Product Change Notification

PCN Number : PCN130

Product Category : Surface Mount PTC Resettable Fuse.

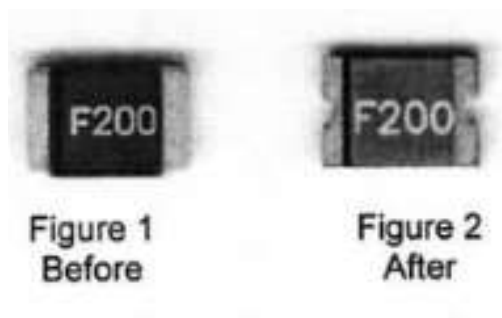
Reason For Change : The Terminal Appearance has been changed from Figure 1 to Figure 2 to improve the solderability. The change has been made to 0805, 1206 1210 & 2920 footprint. This change has no effect on the Electrical / Mechanical / environmental performance.
